UNITED STATES PATENT AND TRADEMARK OFFICE

Office Action Summary	Application No. 10/726,898	Applicant(s) WAWRZYNOWSKI, MICHAEL	
	Examiner Shian T. Luong	Art Unit 3728

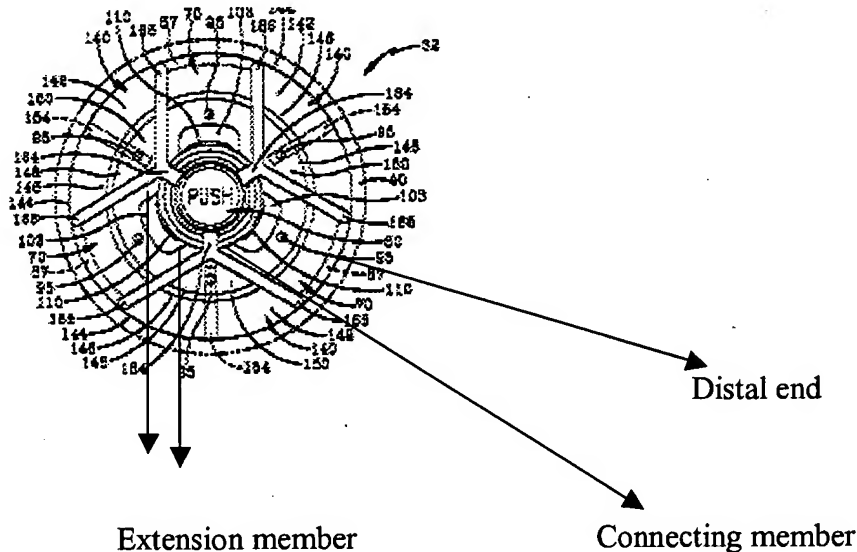
3. Claims 1-~~6~~,8-10,12-14 are rejected under 35 U.S.C. 102(b) as being anticipated by Belden, Jr. (US 6,412,631). Belden.Jr. discloses an apparatus for holding a compact disk having a central hole comprising a body portion with at least three arms 70 each extending radially inward from a distal end connected to the body portion to an engageable end 125 receivable within the central hole, the engageable end having at least one extension member connected to the body portion; and wherein each of the arms has a first pivot axis 86 positioned substantially the distal end, second pivot axis 102 positioned substantially at the extension member, and a third pivot axis 92 positioned in between the first and second pivot axes.

With respect to claim 2, wherein each engageable end further comprises at least one lip

110 securing a top surface of the disk when in a disk-locking position.

With respect to claim 3, the body portion has a gap 166 positioned around each arm allowing the arms to pivot about the first, second and third axes without contacting the body portion.

With respect to claim 4, further comprising a disk-receiving portion 12 and a cover portion 14 that move relative to each other via hinged region 18 to form an enclosure around the disk, the body portion being positioned within the disk-receiving portion.

With respect to claim 5, first, second and third pivot axes have first vertical plane that positioned towards the central hole of the disk and away from a second vertical plane created contact points when the cover portion is pressed against the engageable portions. Applicant has not positively claimed the pressing motion.

With respect to claim 6, inasmuch as the examiner can interpret the limitation in claim 6, the axes are within the substantially triangular shaped arms.

With respect to claim 8, wherein the engageable ends form pie-shaped engageable region receivable within the central hole of the disk.
